## **STAFF REPORT**

**TO:** City Council  
**FROM:** Emily Becker, Planning Director  
**AGENDA ITEM:** The Legacy at North Star Final Plat and Planned Unit Development Plans and Zoning Map Amendment  
**REVIEWED BY:** Jack Griffin, City Engineer

GWSA Land Development is requesting Final Plat and Planned Unit Development (PUD) Plans for 59 single family detached homes located on 23.26 acres. This is the 1<sup>st</sup> phase of a 266 single family residential development on +/- 98.93 acres. A portion of the development in the southwest corner of the site is within the Shoreland of Sunfish Lake which triggers the need for a Planned Unit Development because the proposed lots do not meet the lot width and impervious requirements for Natural Environment lakes; because the density exceeds the allowable density with the Village Urban Low Density Residential land use category, and because the Applicant is proposing various other deviations from some zoning standards.

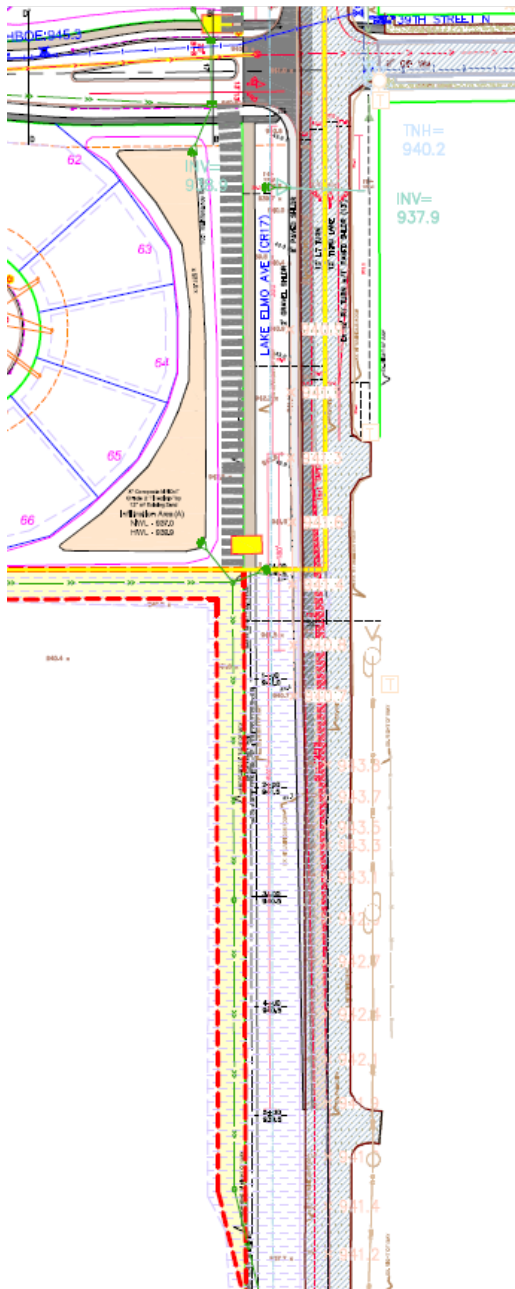
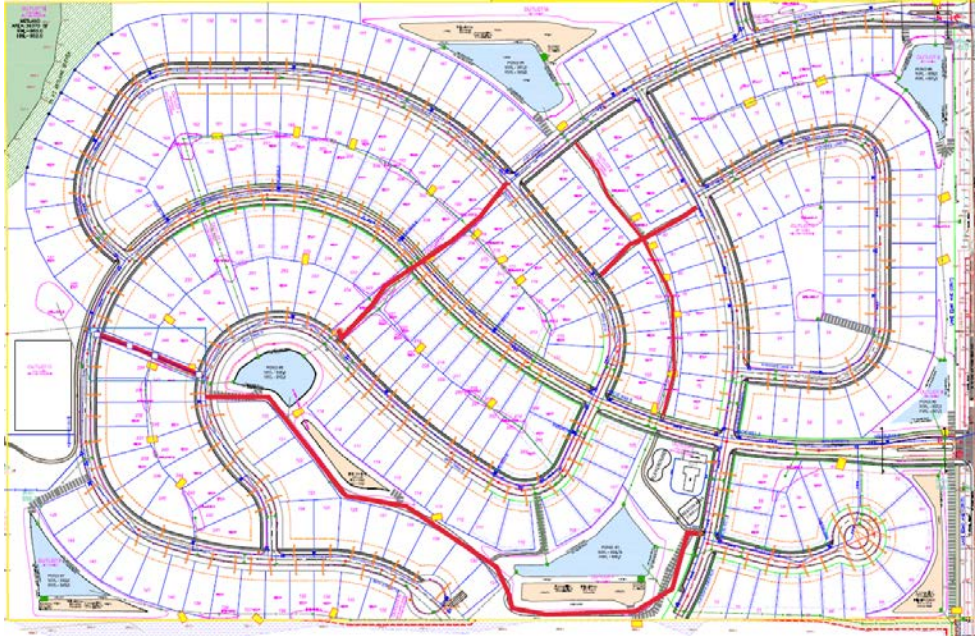
Another condition was that a trail be provided from 39<sup>th</sup> Street to the southern limits of the plat and that the future County right-of-way area along Lake Elmo Avenue of the parcel to the south

of the plat be graded for a future bituminous trail extension (grade ready trail) along the storm sewer outfall pipe location.

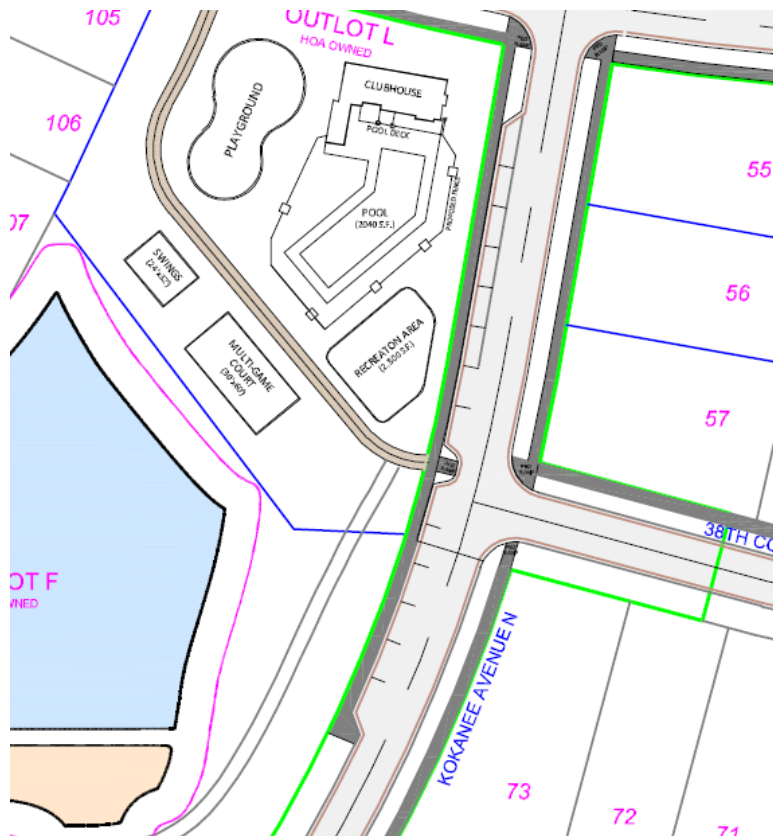
- 13. That wetlands and wetland buffer areas be contained within outlots outside of lot areas and dedicated to the City.*

The preliminary plat shows that with buffer averaging this wetland buffer has been contained within Outlot N of the preliminary plat. This condition is not applicable to the 1<sup>st</sup> Addition.
